MISTER CAR WASH

SITE CONSTRUCTION PLANS

SITE PLAN SUBMITTAL

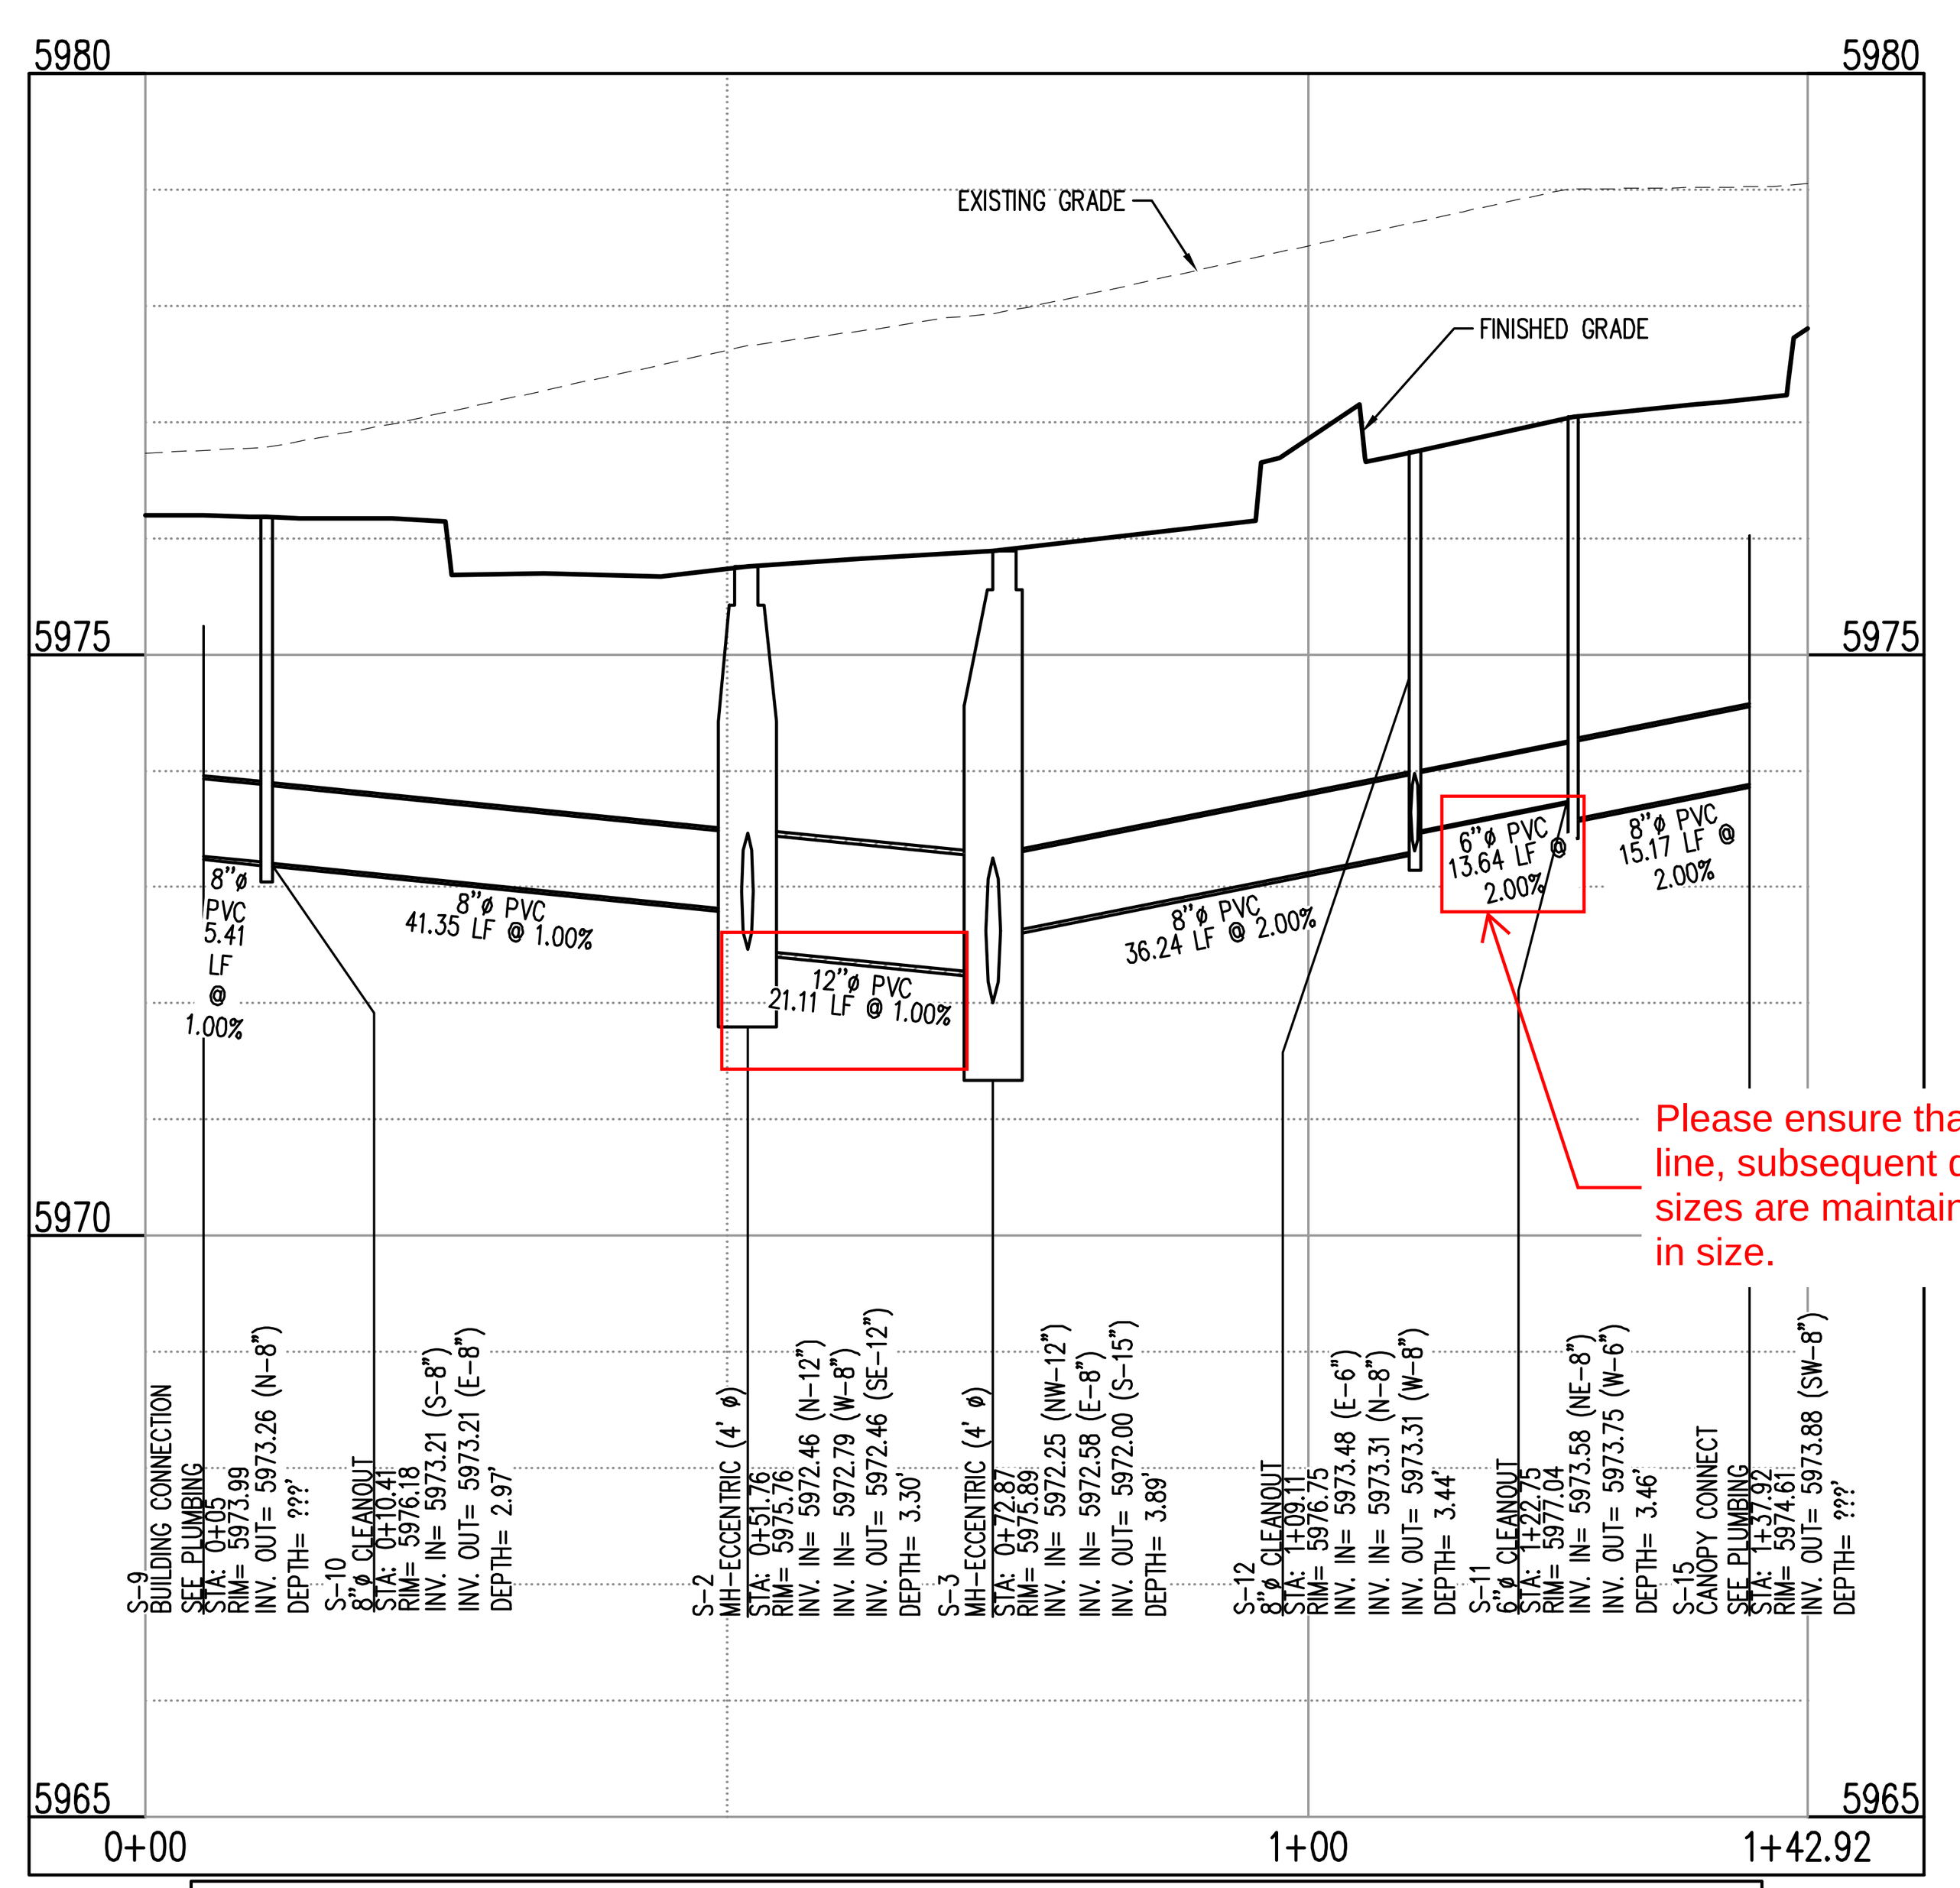
Please ensure that within each storm line, subsequent downstream pipe sizes are maintained or are increased in size.
